Project	IEEE 802.16 Broadband Wireless Access Working Group < http://ieee802.org/16 >		
Title	Changes to constellation errors		
Date Submitted	2003-07-03		
Source(s)	Tal Kaitz	Voice:	+972 54 22 56 48
	Naftali Chayat	Fax:	+972 3 6456273
		mailto: tal.kaitz@alvarion.com	
	21, HaBarzel Street Tel Aviv, Israel		
Re:	IEEE 802.16d Sponsor Ballot		
Abstract			
Purpose			
Notice	This document has been prepared to assist IEEE 802.16. It is offered as a basis for discussion and is not binding on the contributing individual(s) or organization(s). The material in this document is subject to change in form and content after further study. The contributor(s) reserve(s) the right to add, amend or withdraw material contained herein.		
Release	The contributor grants a free, irrevocable license to the IEEE to incorporate material contained in this contribution, and any modifications thereof, in the creation of an IEEE Standards publication; to copyright in the IEEE's name any IEEE Standards publication even though it may include portions of this contribution; and at the IEEE's sole discretion to permit others to reproduce in whole or in part the resulting IEEE Standards publication. The contributor

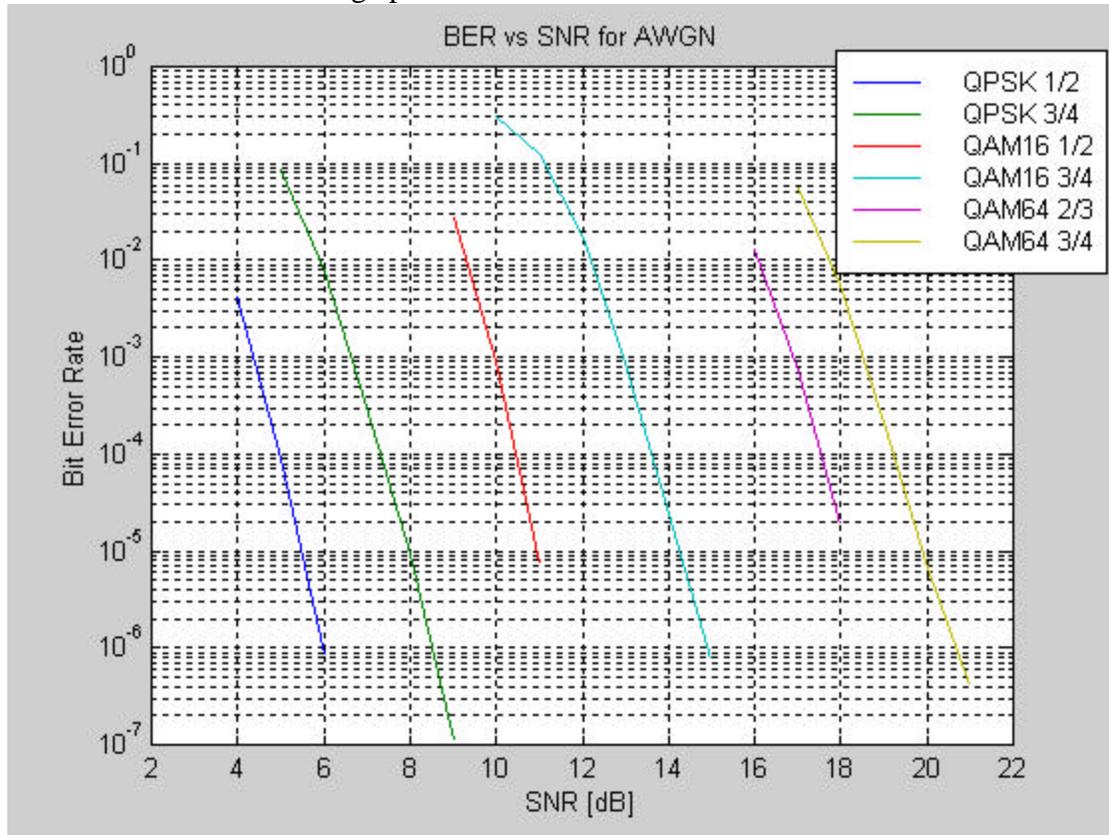
To determine the realistic SNR values the result of simulations are shown. The simulation conditions are:

1. Mandatory CC+RS coding.
2. Full BW
3. 400 bytes packets. 20K packets were simulated. (64Mbits)
4. Channel estimation from preamble.
5. No frequency offsets, quantization effects phase noise etc. (These are considered part of implementation loss).

The results are shown in the graph and table below¹.

¹ Note: Sometimes the curves stops at 10⁻⁵. This is because simulation steps were 1dB and the RS+CC error curves decay rapidly.
